RESPONSE LETTER NO. 3 TO REQUEST FOR INFORMATION

Project Title: **Improvements to SW 87 Avenue Bridge Over Canal C-100**
Project No.: **20220010**

(Page 10 – Sheet 66 of 81)

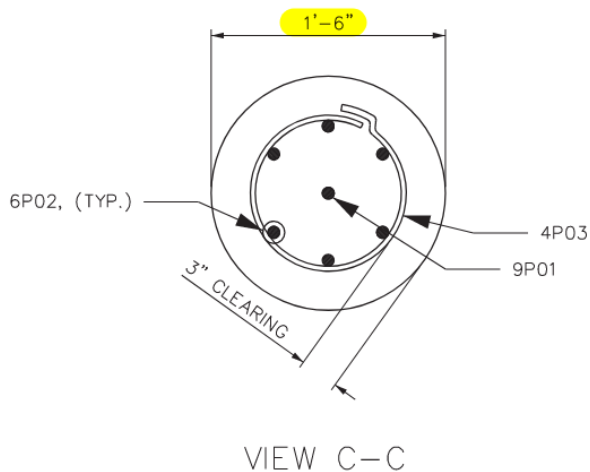
QUESTION: 1) Could you please address the following: In reference to the steel reinforcement – The section view and reinforcement bar list depict reinforcement for an 18” auger cast pile instead of a 24” auger cast pile as per the pile data table.

QUESTION: 2) The section view depicts a #9 center bar per pile – quantity of 9P01 bars should be 22, consistent with the number of piles per plan; however, the reinforcement bar list denotes a quantity of 26.

- The section view and reinforcement bar list depict reinforcement for an 18" auger cast pile instead of a 24" auger cast pile as per the pile data table.
- The section view depicts a #9 center bar per pile – quantity of 9P01 bars should be 22, consistent with the number of piles per plan; however, the reinforcement bar list denotes a quantity of 26.

RESPONSE: 1) ACP shall be 24” diameter. Please refer to the Revised Sheets for Addendum No. 3.

RESPONSE: 2) The total should be 23 including the test pile. Please refer to the Revised Sheets for Addendum No. 3.
